SUBJECT: ISSUANCE OF AMENDMENTS FOR THE PALO VERDE NUCLEAR GENERATING STATION
UNIT NO. 1 (TAC NO. M90907), UNIT NO. 2 (TAC NO. M90908), AND UNIT
NO. 3 (TAC NO. M90909)

SAFETY EVALUATION BY THE OFFICE OF NUCLEAR REACTOR REGULATION
RELATED TO AMENDMENT NO. 91 TO FACILITY OPERATING LICENSE NO. NPF-41,
AMENDMENT NO. 79 TO FACILITY OPERATING LICENSE NO. NPF-51,
AND AMENDMENT NO. 62 TO FACILITY OPERATING LICENSE NO. NPF-74
ARIZONA PUBLIC SERVICE COMPANY, ET AL.
PALO VERDE NUCLEAR GENERATING STATION, UNIT NOS. 1, 2, AND 3
DOCKET NOS. STN 50-528, STN 50-529, AND STN 50-530

Fig 5.1-3

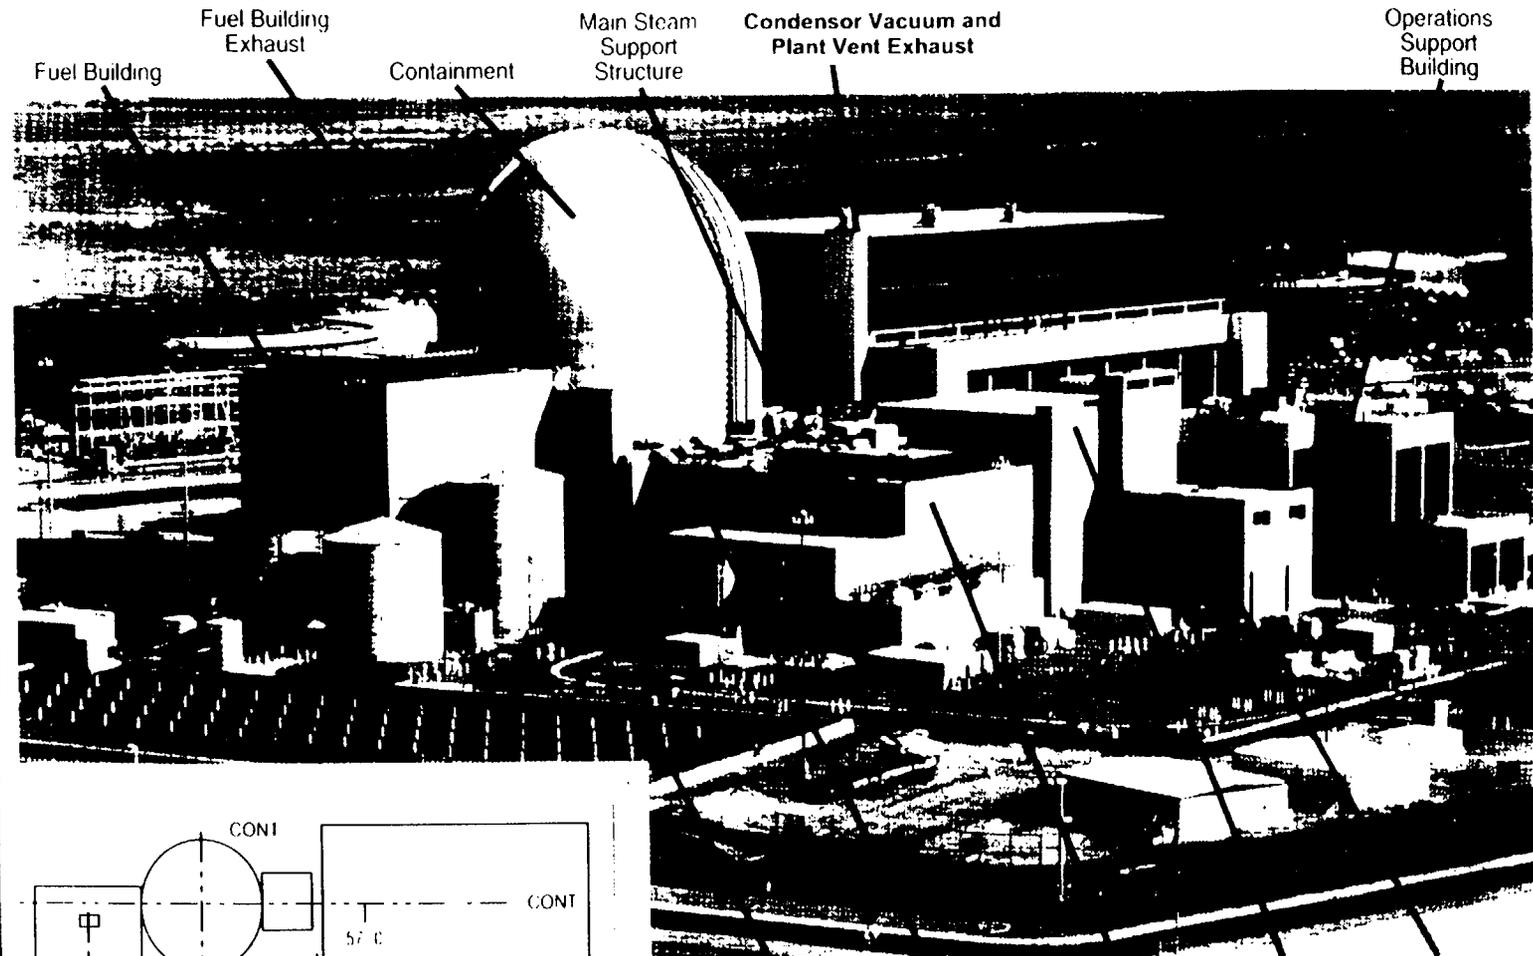
These amendments delete the condenser vacuum exhaust release point reference on Figure 5.1-3 and combine it with the plant vent exhaust release point on the revised Figure 5.1-3. In addition to the figure change, Bases Section 3/4.3.3.6 is changed to reflect the removal of radiation monitor RU-142 and the relocation of RU-144 and RU-146 from Table 3.3-13 (deleted by Amendments 62, 48, and 34, for Units 1, 2, and 3, respectively) to the Offsite Dose Calculation Manual (ODCM).

Existing TS Figure 5.1-3 depicts separate release paths for the condenser vacuum and the plant vent exhaust; the revised figure depicts one combined release path. The existing plant effluent radiation monitors (RU-143 and RU-144) will then serve to monitor both the plant vent and the condenser air removal system effluent. High-range radiation monitor RU-142 for the condenser air removal system effluent is being removed as it is similar to the existing high-range plant effluent monitor. The existing plant effluent radiation monitors consist of a low- (or normal-) range unit RU-143 and, as stated above, a high-range unit RU-144. Low-range monitor RU-141 for the condenser air removal system effluent) has been changed to an in-duct monitor.

The proposed amendment would delete the condensate vacuum exhaust release point reference on existing TS Figure 5.1-3 and combine it with the plant vent exhaust release point on the revised TS Figure 5.1-3.

Combining the condenser vacuum and plant vent exhaust into a single release path does not involve a significant reduction in safety. The change involves the removal of one high-range monitor in the condenser vent; however, its function is provided by the high-range monitor in the plant vent. The ranges of the monitors are the same. The existing plant effluent radiation monitors will serve to monitor both the plant and condenser air removal system effluent. The normal-range monitors for the plant vent effluent and the condenser air removal system effluent have the ability to adequately detect radiation in these effluents over 5 decades. These monitors, which are not changed by these amendments, have the ability to detect the anticipated radiation releases via these effluents. Therefore, the proposed change is acceptable.

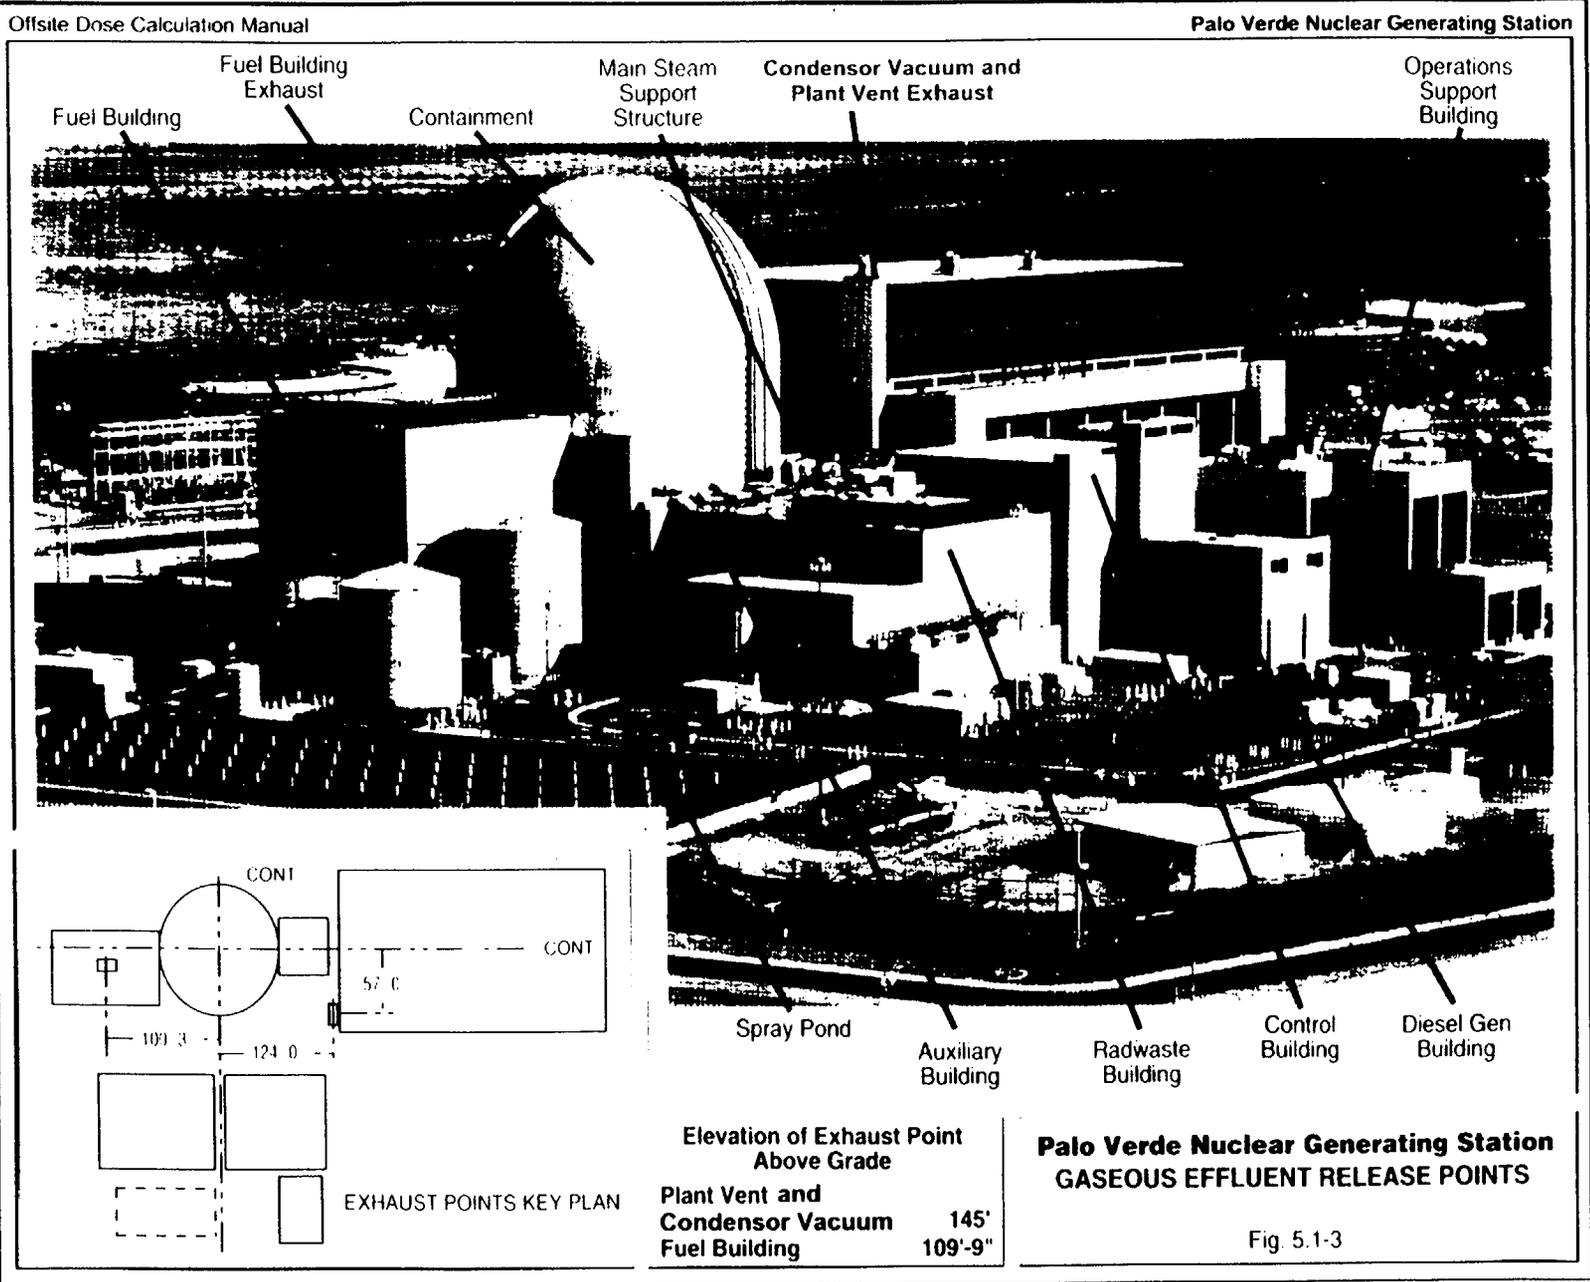
These amendments delete the condenser vacuum exhaust release point reference on Figure 5.1-3 and combine it with the plant vent exhaust release point on the revised Figure 5.1-3. In addition to the figure change, Bases Section 3/4.3.3.6 is changed to reflect the removal of radiation monitor RU-142 and the relocation of RU-144 and RU-146 from Table 3.3-13 (deleted by Amendments 62, 48, and 34, for Units 1, 2, and 3, respectively) to the Offsite Dose Calculation Manual (ODCM).

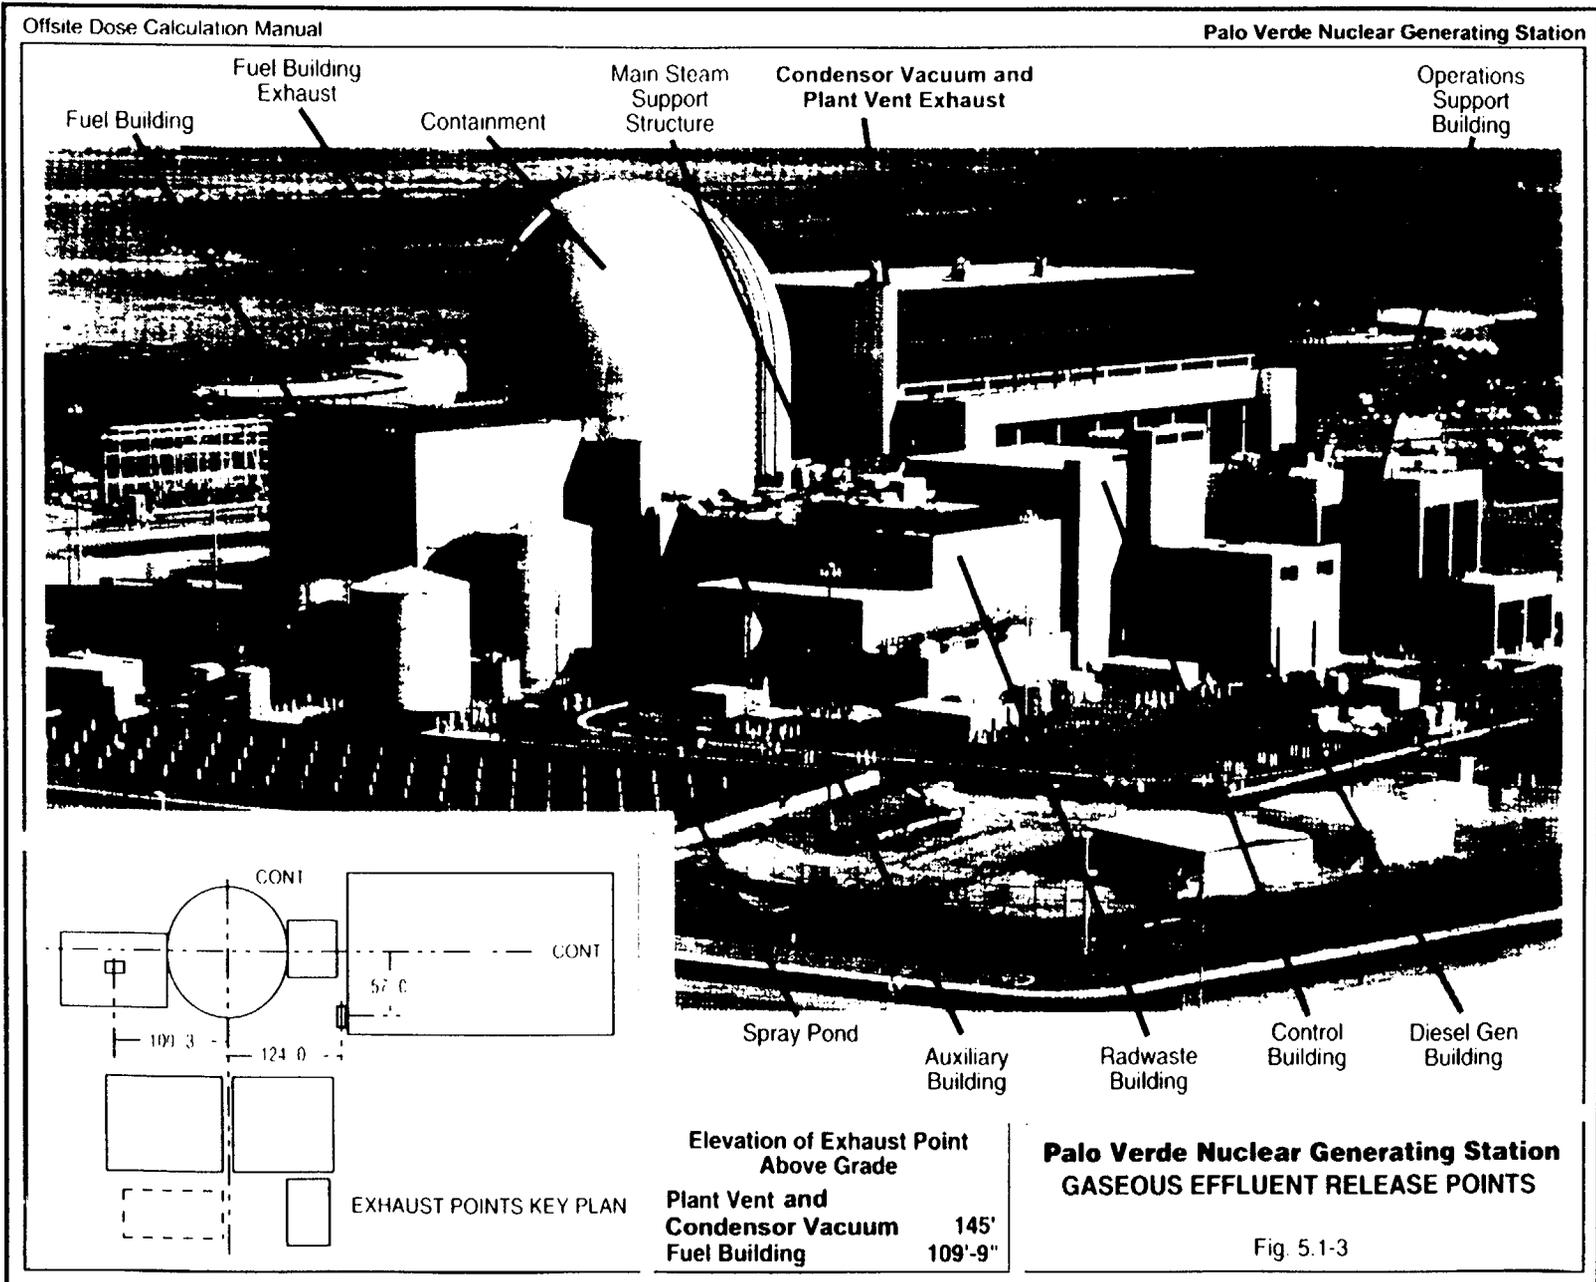
These amendments delete the condenser vacuum exhaust release point reference on Figure 5.1-3 and combine it with the plant vent exhaust release point on the revised Figure 5.1-3. In addition to the figure change, Bases Section 3/4.3.3.6 is changed to reflect the removal of radiation monitor RU-142 and the relocation of RU-144 and RU-146 from Table 3.3-13 (deleted by Amendments 62, 48, and 34, for Units 1, 2, and 3, respectively) to the Offsite Dose Calculation Manual (ODCM).
